511 N Carroll Street
Certificate of Appropriateness
May 6, 2024

Proposed Work

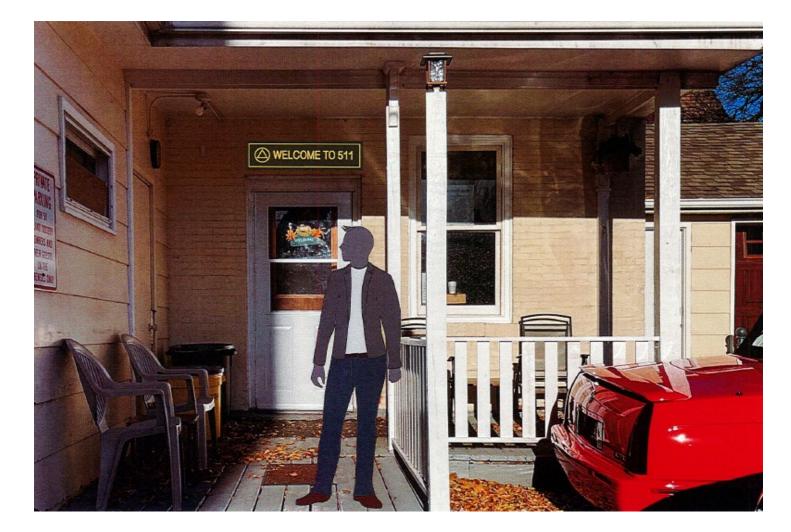
• Install 2 walls signs

Staff believes that the standards for granting a Certificate of Appropriateness are met and recommends the Landmarks Commission approve the project with the following conditions:

1. Install the signage with stainless steel fasteners at the masonry joints.
